FIELD SERVICE BULLETIN

FSB Number:	LVCCFSB2003-90
Author:	Dale Jenkins
Date:	September 29, 2003
Total No. of Pages:	2
Subject:	A920 (Paragon) Headset Detect/Undetect Issue
Model Affected:	All A920 (Paragon)
Level of Repair:	3, and 4

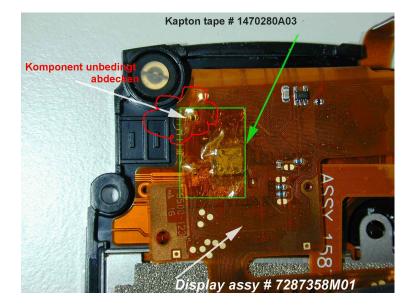
Customers may complain of headset not working or headset detect/undetect failures. This can be caused by an exposed resistor (Reference designation R206) on the display flex. The resistor grounds the sense line for headset detect/undetect. The failure can be intermittent.

Manufacturing has begun placing Kapton tape (part # 1470280A03) over the resistor on the display flex as per photo on page 2.

- 1.) Check to see if there is tape on display flex as shown in photo. If tape is there go to step (A), If not taped go to step (B).
 - a. Inspect tape for wear and tear or abrasions, replace with new tape (part # 1470280A03) if any are found. If no issues found with tape, proceed with normal troubleshooting procedures.
 - b. Place tape (part # 1470280A03) on display flex as shown in photo, reverify failure. If headset detect/ undetect failure persists' proceed with normal troubleshooting procedures.
